Investigation of the 2012 Woodlot 1572 Landslide

Investigation of the 2014 Woodlot 1572 Landslide

RE: Woodlot 1572 landslide field review (April 2012)

Figure 2 – Location of features observed in the field.

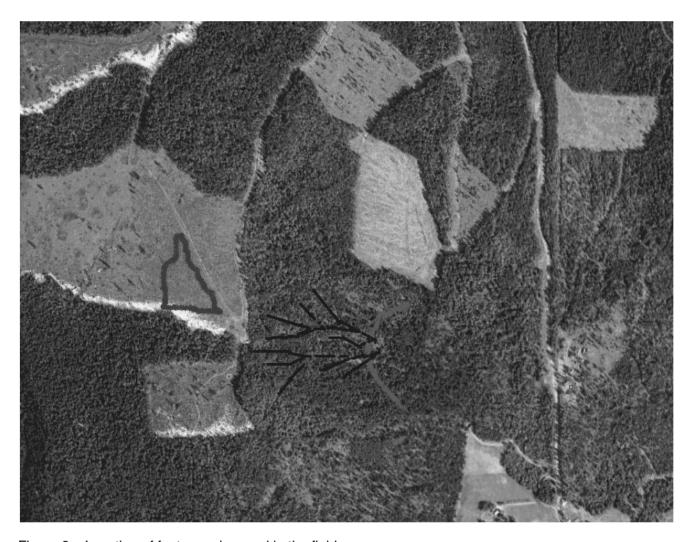
Red outline = area of influence by road in B-3 with no cross drains installed (max. 2ha).

Blue lines = complex of existing, well defined, incised gullies converging downslope

Magenta thick line = existing boundary of mixed deciduous trees with historical high frequency of disturbance

- 2) Multiple landslide events occurred in the Salmon Arm area during the April 26 rain on snow event.
- 3) The physical area (shown above in red) influenced by the spur road in relation to collecting and redirecting surface water flow is very small in relation to the watershed area or area of surface water collection above the land slide head scarp. The area in the cutblock to the west or left of the red polygon in Figure 2 drains to the west, away from the area being investigated. Based on the pre-existing complex of well defined gullies (shown above in blue) that all converge down slope and lead to the initiation point of the landslide, the water would likely have ended up in the same draw if the road was not present. Although the road changed the surface drainage on a micro site scale, the water that ultimately resulted in the landslide was being introduced on a macro scale to the entire surrounding area. The relatively small flat 2 ha collection area above the spur road may not have influenced the initiation of the landslide.

- 4) There was an abundance of indicators found in the field that show the immediate area where the landslide initiated and ran out had very high levels of historical disturbance (area shown in magenta in Figure 2 above). In the area immediately surrounding the initiation point of the landslide, there are several other smaller slumps and small landslide disturbances from previous years.
